HINT'S AND KINK'S

COBRA 140GTL/142GTL/148GTL

SUBJECT: Regulator IC shorting out in the 140GTL, 142GTL and 148GTL. IC-5 (140 & 142GTL), IC-4 (148GTL).

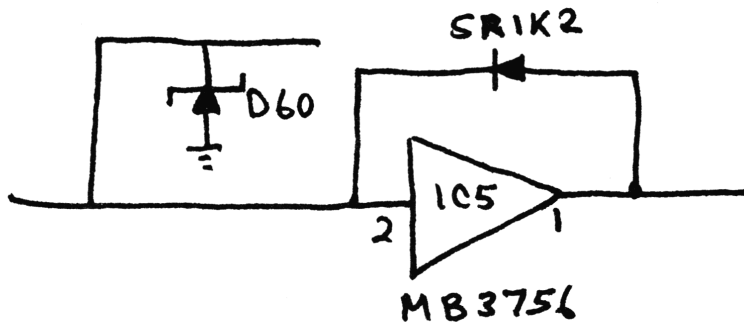
SYMPTOM: High AM power output (10 watts) and low modulation weak of no receive.

SOLUTION: Replace IC-5 (IC-4 for 148GTL) and change D-60 (D-44 for 148GTL) to a 18.2 volt zener diode. Add a SR1k2 diode from pin 1 to pin 2 of IC-5 (IC-4 for 148GTL). (Use Diode) Remove from D-60/44.

Sub 16.2 Volt Zener 152-057-9-001. 18.2 Volt Zener (P/N N.A. as yet) to be used when in stock.

NOTE: This modification should be done on all radios In-Warranty repair. If IC-5 (IC-4) checks good, only make diode changes.
